U.S. Department of the Interior BUREAU OF LAND MANAGEMENT Sundry Print Reportu

Well Name: RODEO ROSIE Well Location: T24N / R10W / SEC 22 / County or Parish/State: SAN

Type of Action: Plug and Abandonment

Notice of Intent - Plug and Abandonment

Planned P & A Wellbore Schematic

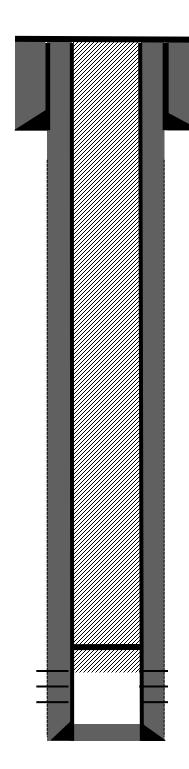
- 1. Plugging operations authorized are subject to the attached "General Requirements for Permanent Abandonment of Wells on Federal and Indian Lease."
- 2. The following modifications to your plugging program are to be made: a. Complete wellbore fill up proposal. No changes to the procedure.
- 3. <u>Notification:</u> Farmington Office is to be notified at least 24 hours before the plugging operations commence at (505) 564 7750.

You are also required to place cement excesses per 4.2 and 4.4 of the attached General Requirements.
